Re: 339 West Gorham Street: Oliv Madison

Attached is a minor amendment packet for the Oliv Madison Project. These changes address some program elements (expanded amenity), design refinements, and adding solar to the project. The packet illustrates the changes between the Original SIP document and the proposed amendments. The site plan review/building permit set elevations are also included for reference to show what was approved with the building permit.

UDC MINOR REVISIONS

OLIV MADISON 339 W GORHAM STREET

MADISON, WISCONSIN • DECEMBER 19, 2022

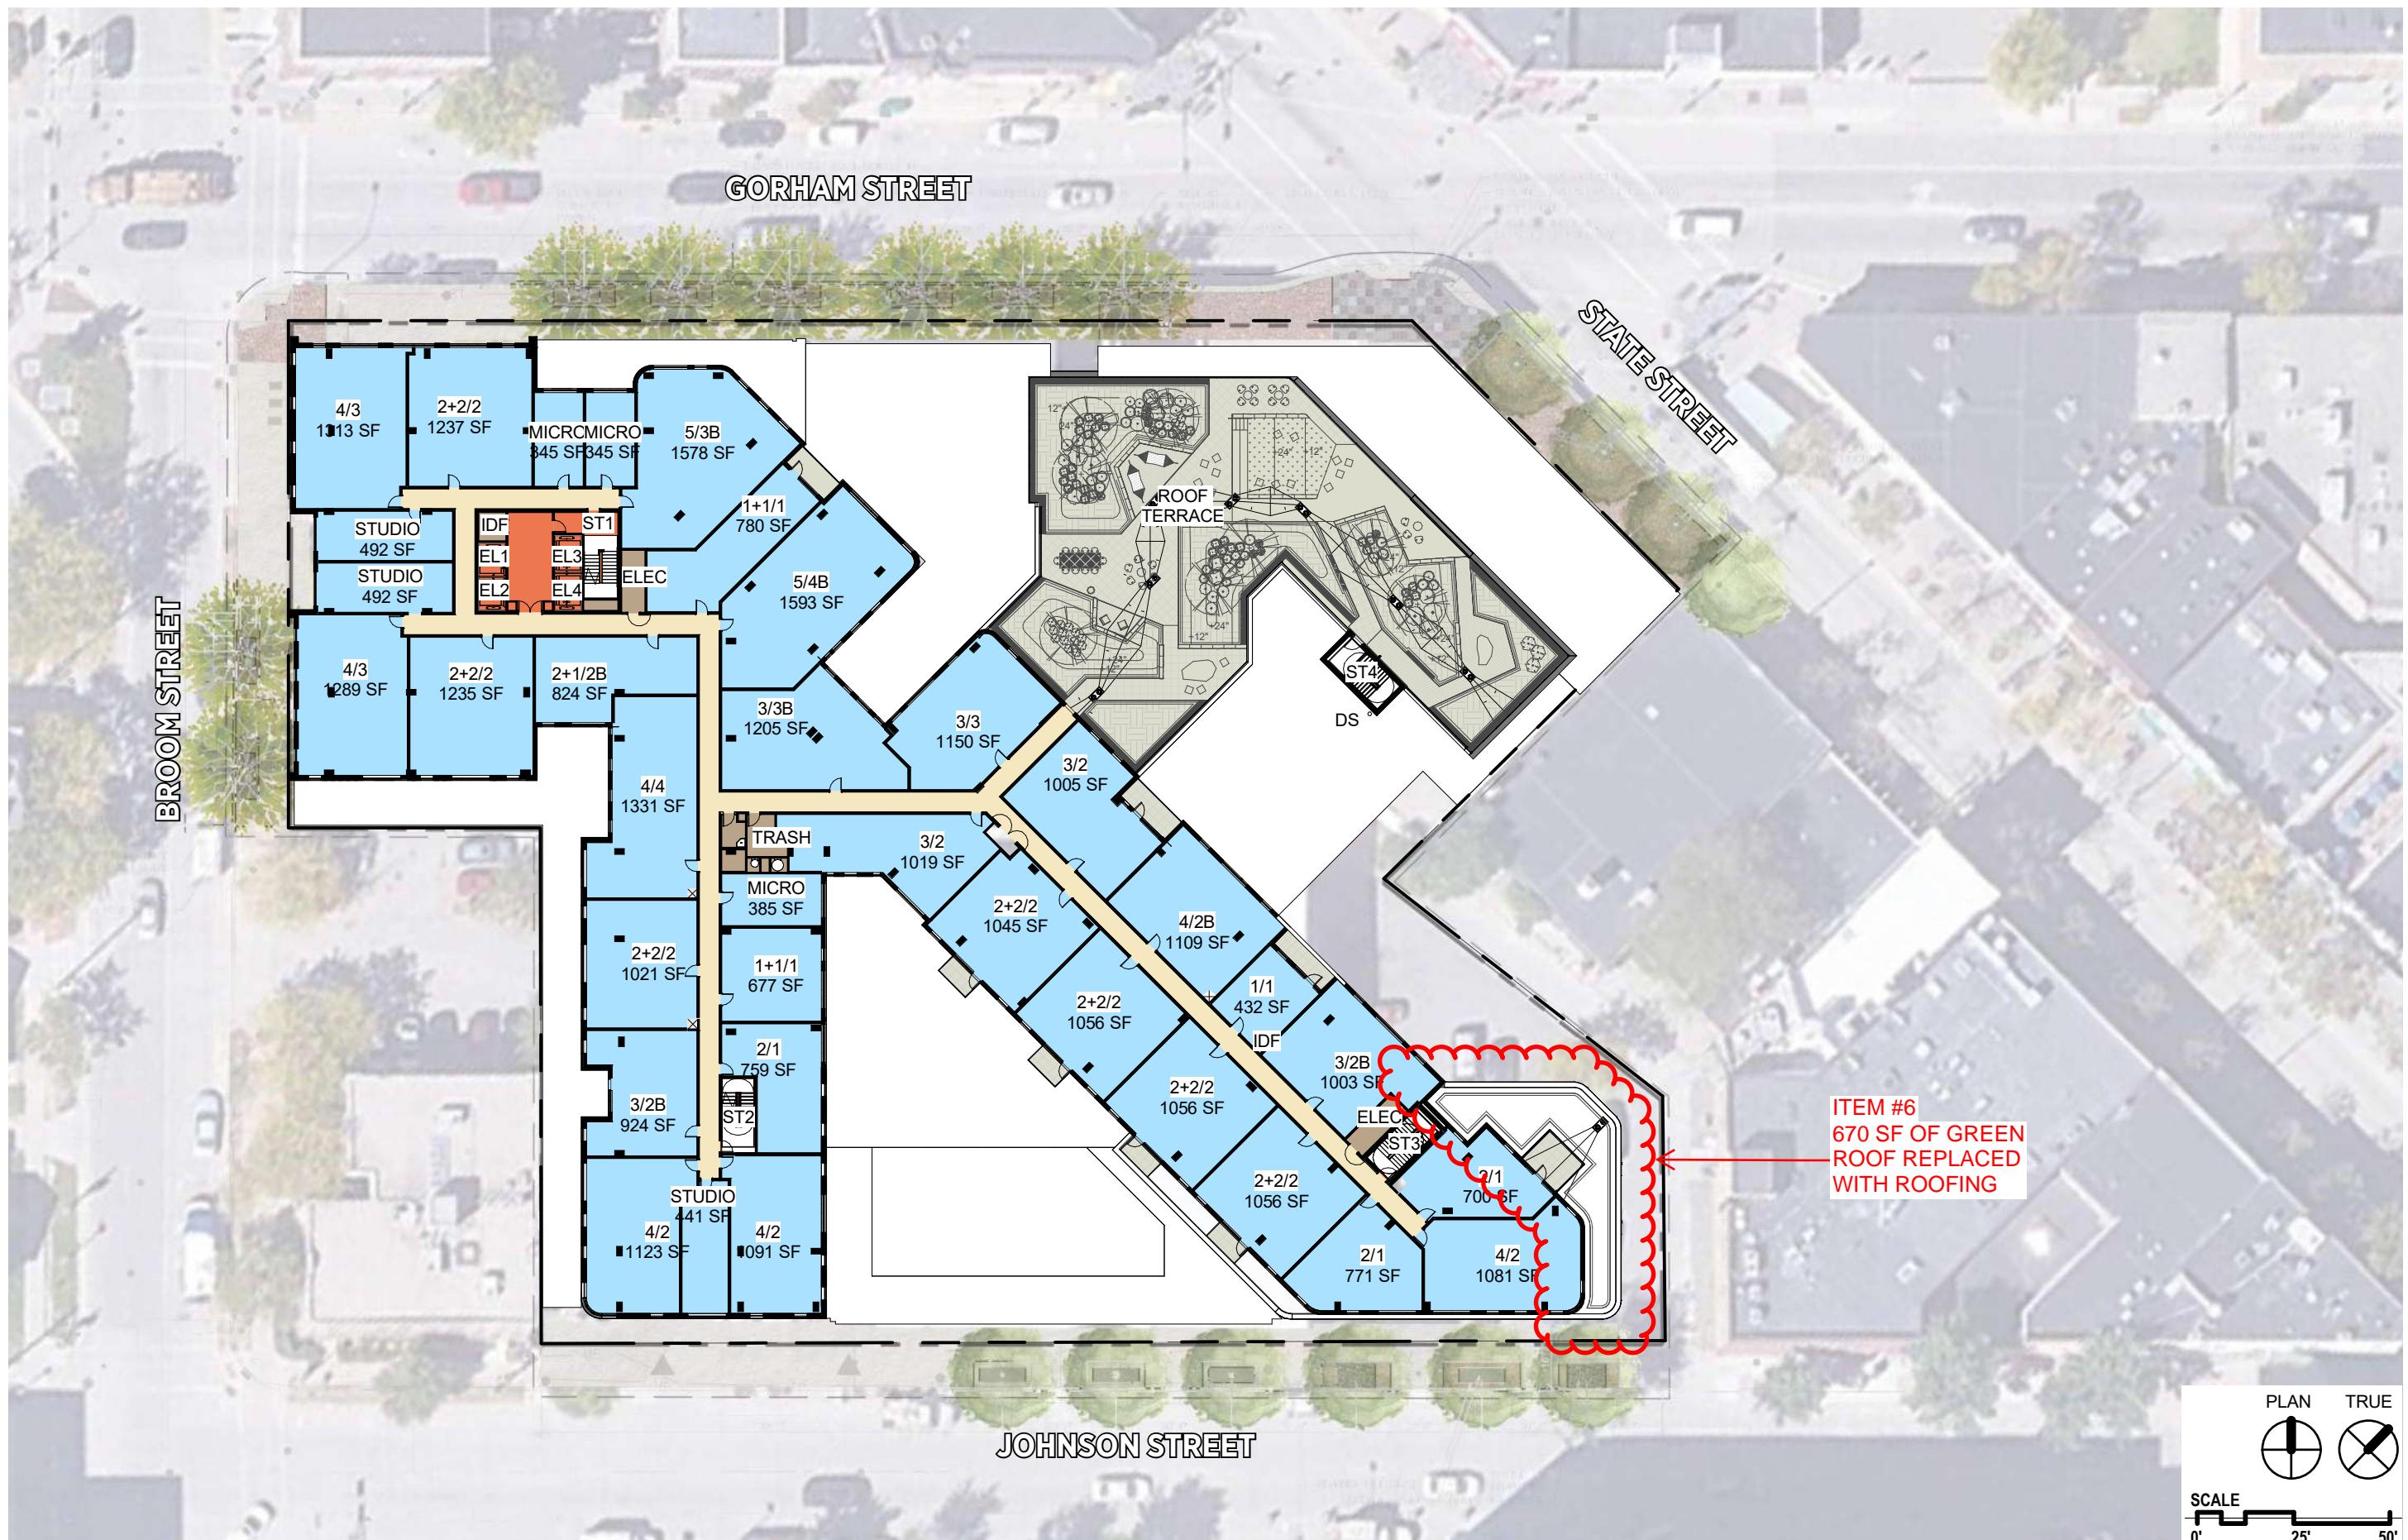
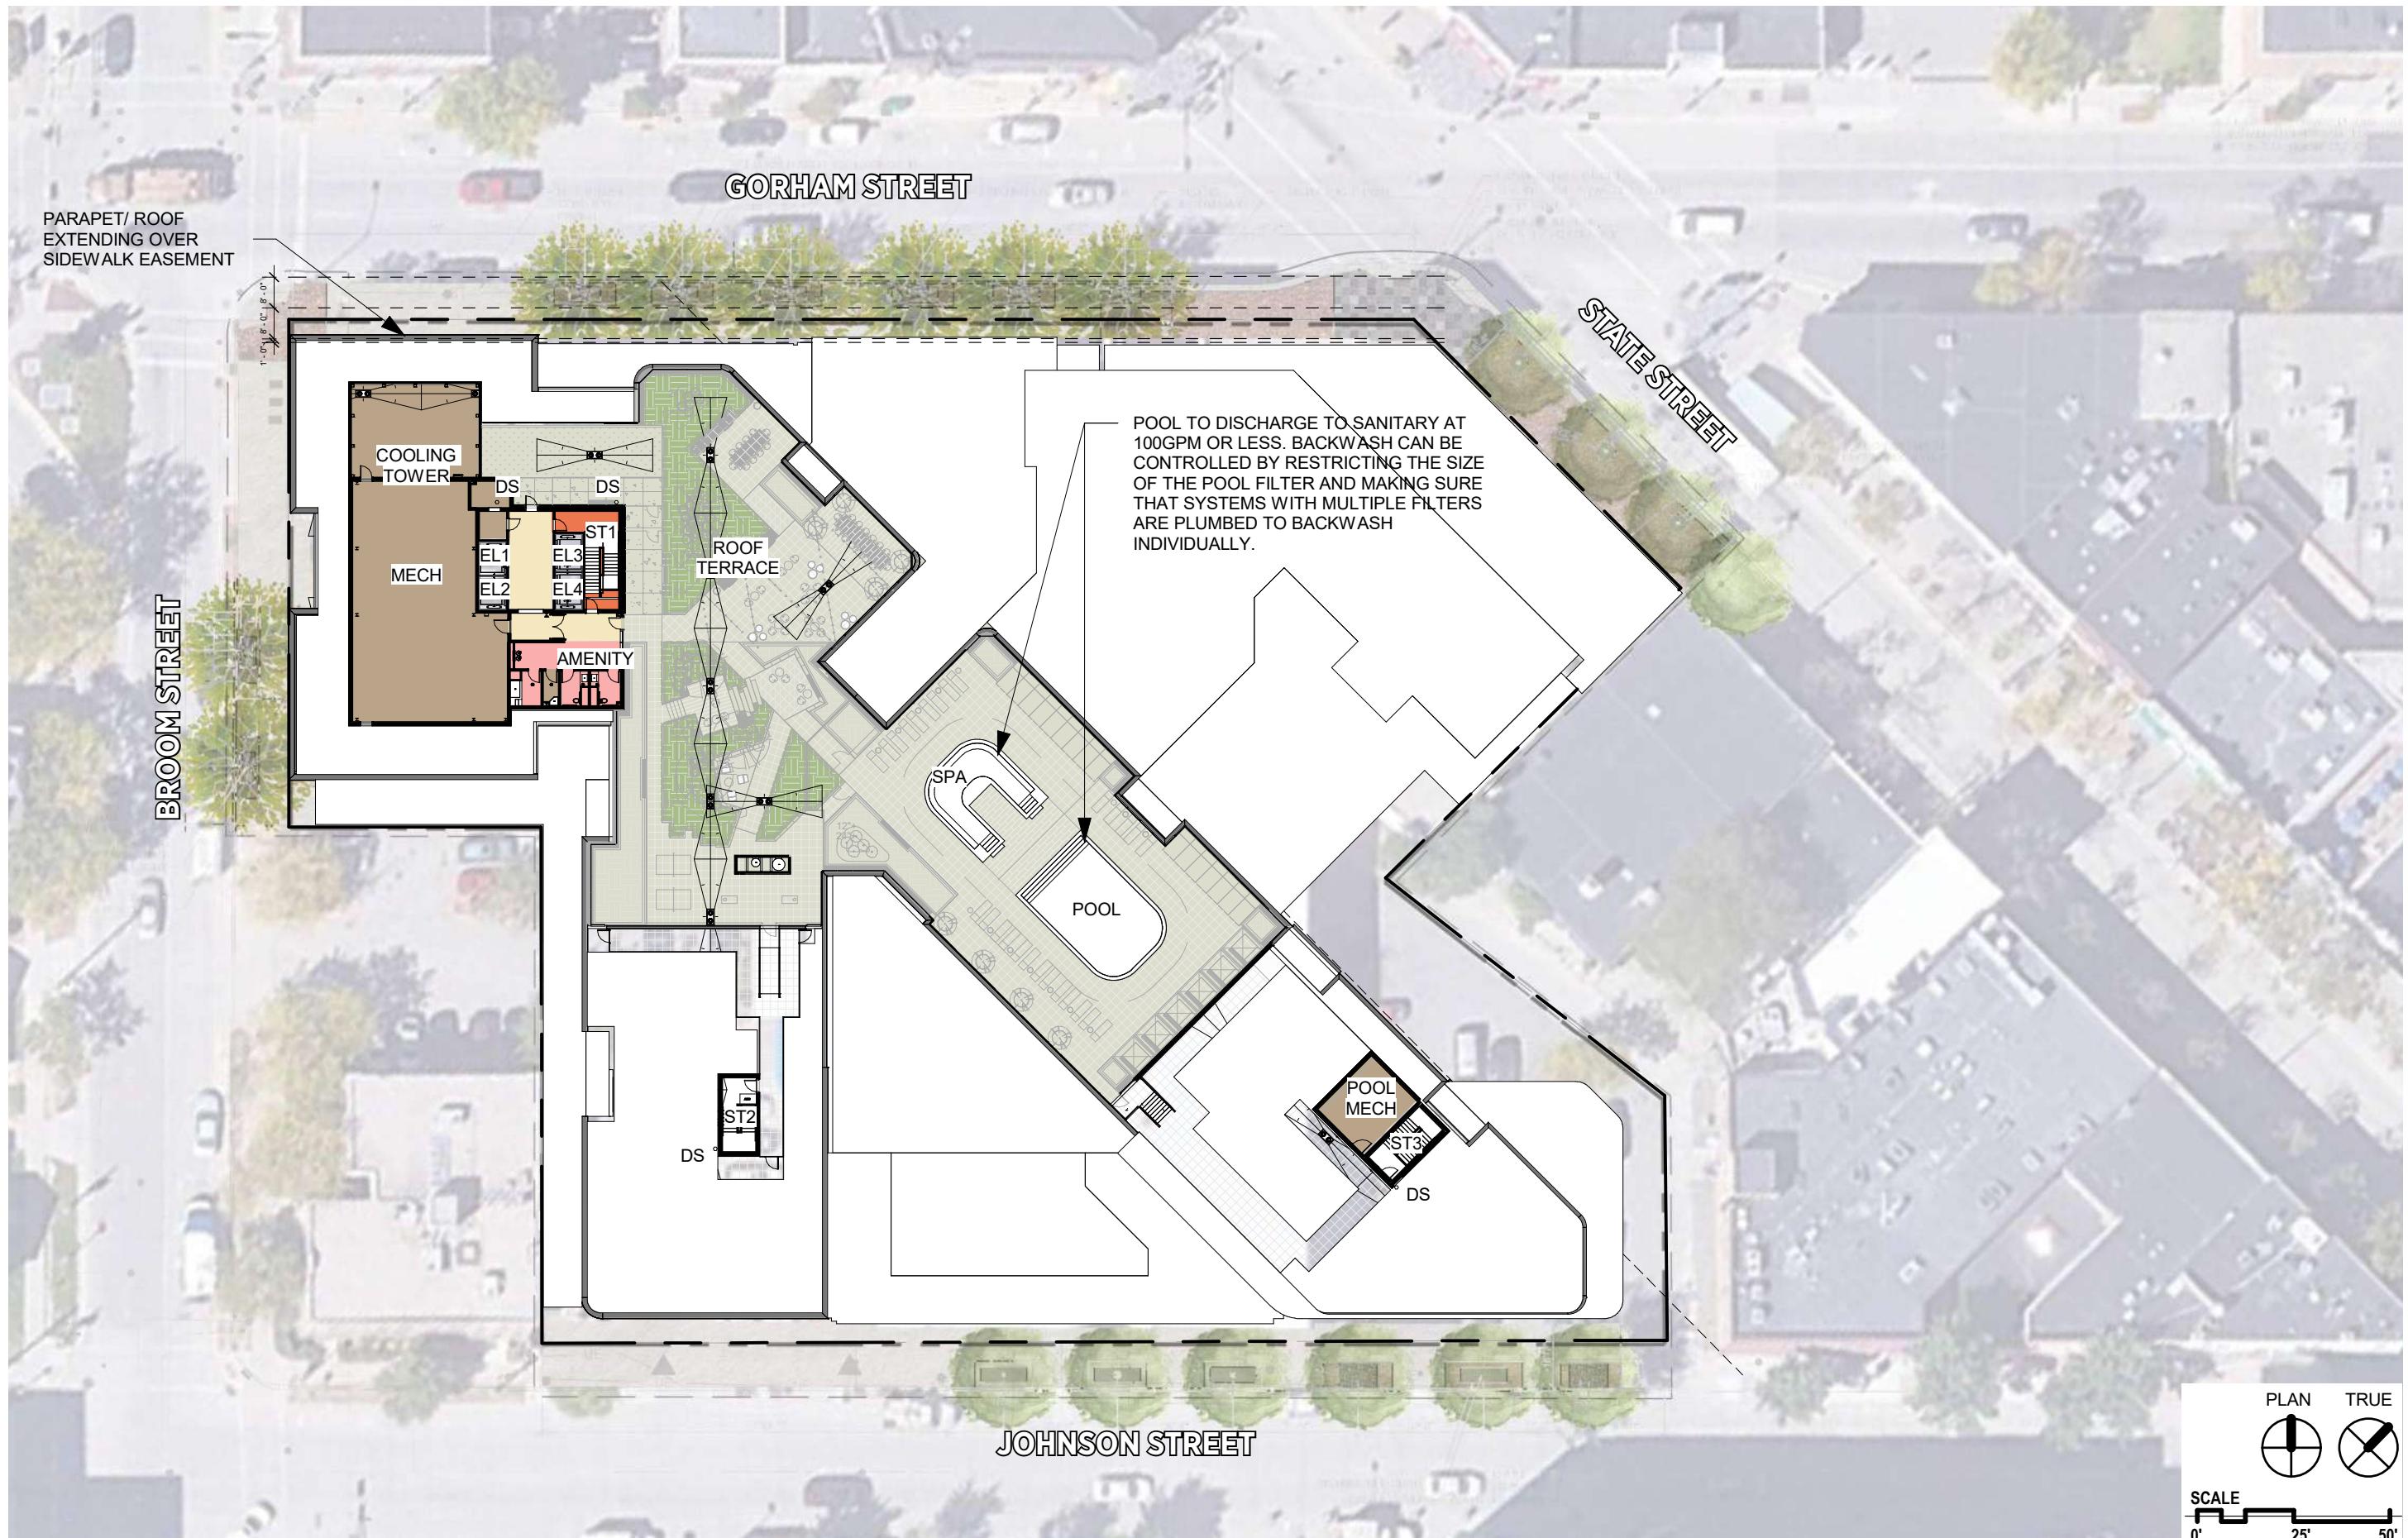
- Item 6. Added Solar Panels and green roof modifications (A45, A46, A47, A49, A51): Reduction of select green roofs for proper maintenance access. The areas deleted required maintenance access through tenant units. The removal of these select green roofs provides the financial ability to add solar panels on the roof. The project added 8,485 SF to dedicate to solar panels.

- i. Note on item 6: The project will still almost double the minimum green roof requirement for stormwater management. 6,600 SF was required. 14,209 SF was provided in approved set. The current proposal includes 11,613 SF of green roof.
